Retrofit SRTA/MSRT Tool Flat Anvil Plate with New Stepped Anvil Plate

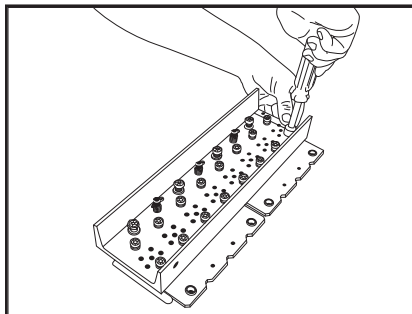
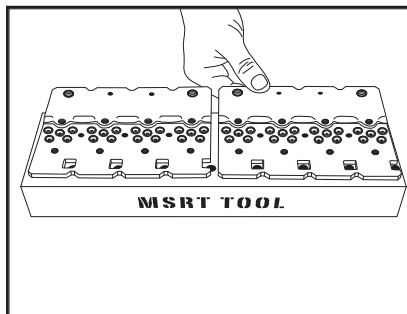
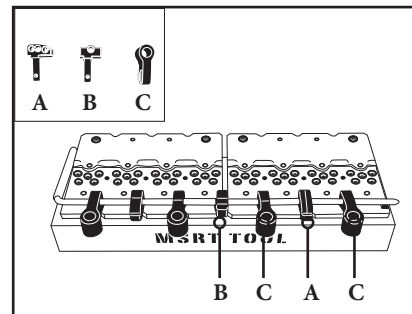
1. Turn the MSRT tool over and remove all existing bolts, cotter pins, and springs.

2. Remove flat anvil plate and replace with the new stepped anvil plate.
